# SERVICE BULLETIN

M1384

## 2015 HARLEY-DAVIDSON STREET FUEL TANK - SAFETY RECALL 0161

Figure 1. Fuel Tank

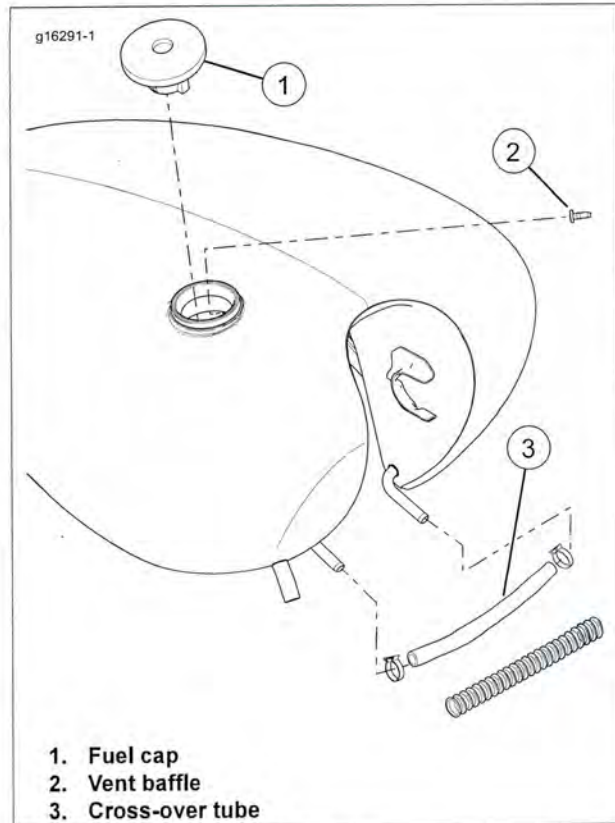
See Figure 1. New fuel tank will come with all components except:

- Vent baffle (2).
- Cross-over tube (3).
- Fuel cap (1).

When removing or installing vent baffle, cover fuel tank inlet to prevent vent baffle from falling into fuel tank.

2. Transfer vent baffle (2) from old tank to new tank.
3. Install new fuel tank. See service manual.
4. Install cross-over tube (3) and **new** clamps.
5. Fill fuel tank with fuel.
6. Install fuel cap (1) from old fuel tank to new fuel tank.

The fuel cap, once installed, must sit undisturbed for a minimum of 12 hours. This allows the cap seal to take the shape of the new tank.

7. After the fuel cap has been installed on the new tank for at least 12 hours, test for leakage between fuel cap and tank. If fuel leak is present, contact Technical Service.
